Re: 327 IAC 3 Construction
Permit Application
Bakers Corner WWTP
Permit Approval No. 24943
Bakers Corner, Indiana
Hamilton County

INDIANA DEPARTMENT OF ENVIRONMENTAL MANAGEMENT
AUTHORIZATION FOR CONSTRUCTION OF
WATER POLLUTION TREATMENT/CONTROL FACILITY
UNDER 327 IAC 3

SUBJECT: **Project:** Bakers Corner WWTP
Location: Bakers Corner, Hamilton County
Units: New WWTP – Influent screening, return activated sludge feed structure, oxidation ditches, secondary clarifiers, RAS/WAS pump station and meter, UV disinfection, cascade aeration, parshall flume, biosolids dewatering, polymer feed system, chemical feed system, laboratory, office, plant drain pump, process and yard piping, valves, emergency power generator, HVAC, electrical, instrumentation, controls mechanical, SCADA system, paving, and landscaping

UV STORAGE BUILDING - PLAN, SECTION AND ELEVATIONS

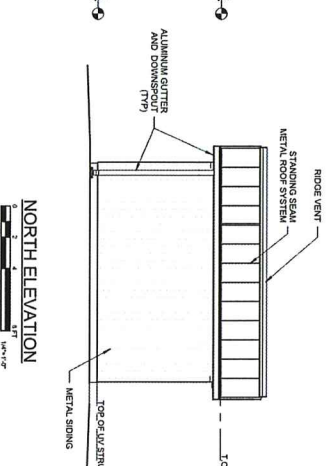
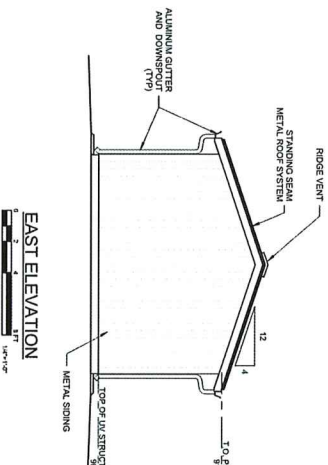
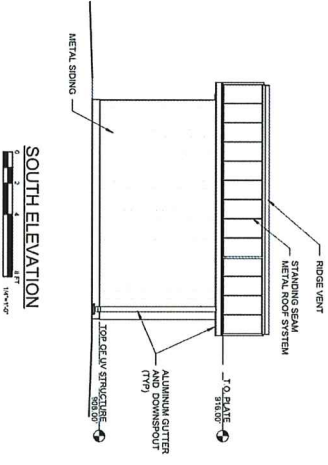
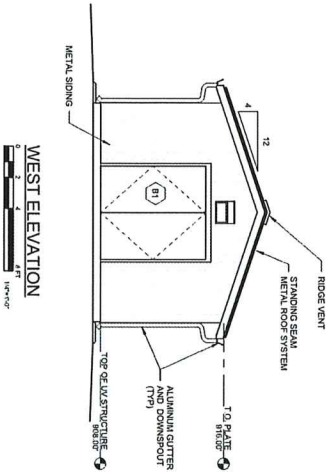
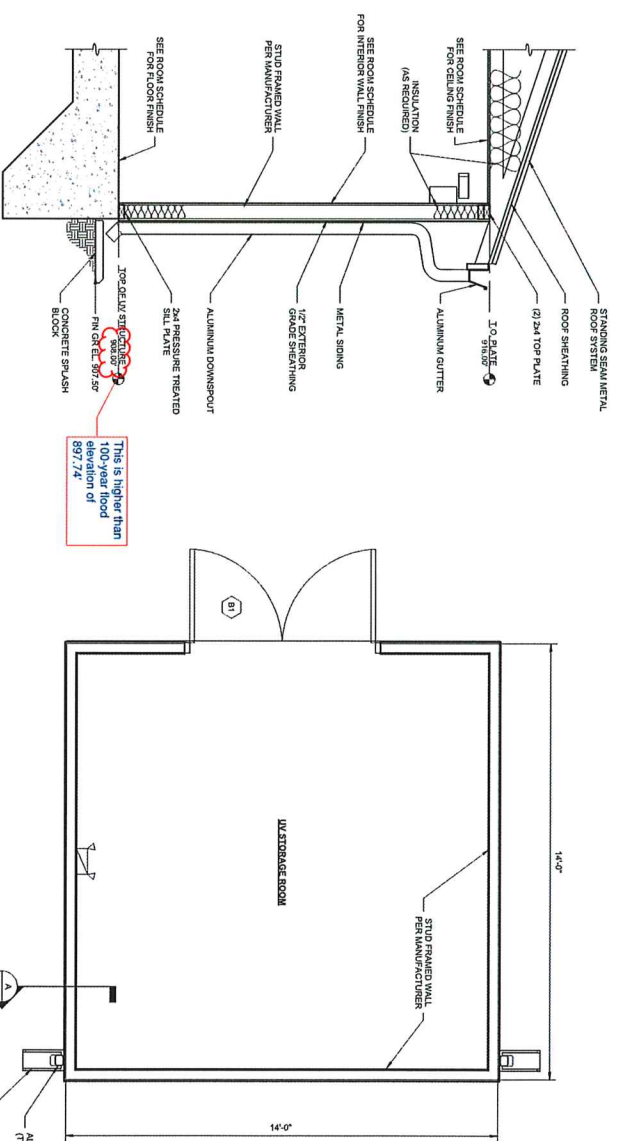
elevation. Typical structure floor elevation is set at 908.00, more than 7 ft above the 100-year flood elevation. Attachment 1A-4 notes the comparison of the 100-year flood elevation to structure elevations as shown on Sheets 6C2 and 10A1 of the complete drawing set. All other WWTP structures, electrical, and mechanical equipment will also be protected from physical damage by the historical 100-year flood.

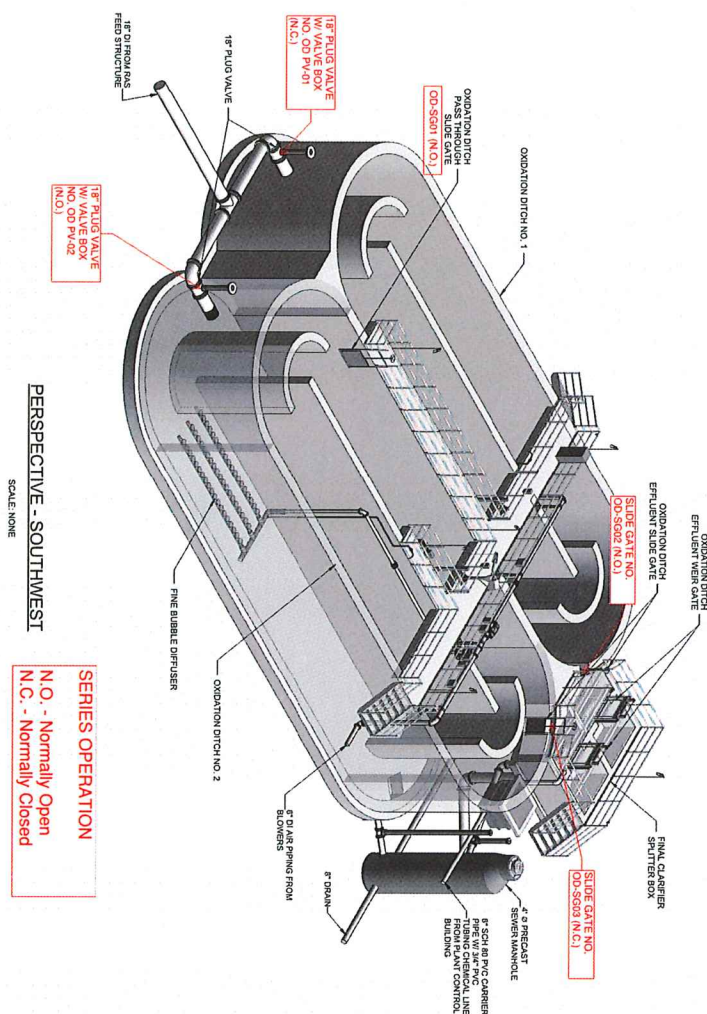
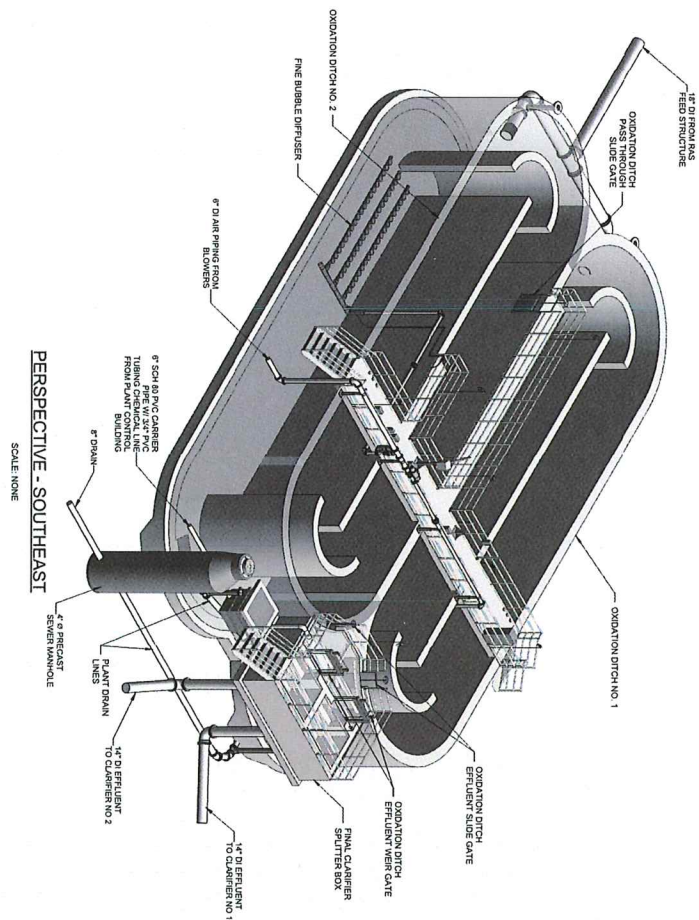
7. *The proposed biological nutrient removal system resembles a previous Sanitaire design that I reviewed (Bioloop oxidation ditch). While I recognize the importance of aerobic and anoxic zones, the proposed new oxidation ditches raise several concerns. Please provide sufficient justification for the following questions and/or revise the design to address any concerns.*
 - a. *The design summary states that there are "two (2) in series oxidation ditches," but the process flow diagram (sheet 1G5) and oxidation ditch plan (sheet 4C1) show the oxidation ditches in parallel. Furthermore, the design summary indicates that there is no method for flow split control.*

The ditches are designed to operate in series during flows equal to and greater than the average design flow of 0.5 MGD. A pass-through slide gate (OD-SG01) is provided between the two ditches (shown on Sheet 4C2) to allow for series operation of the oxidation ditches. Please see Attachment 7A-1 for a
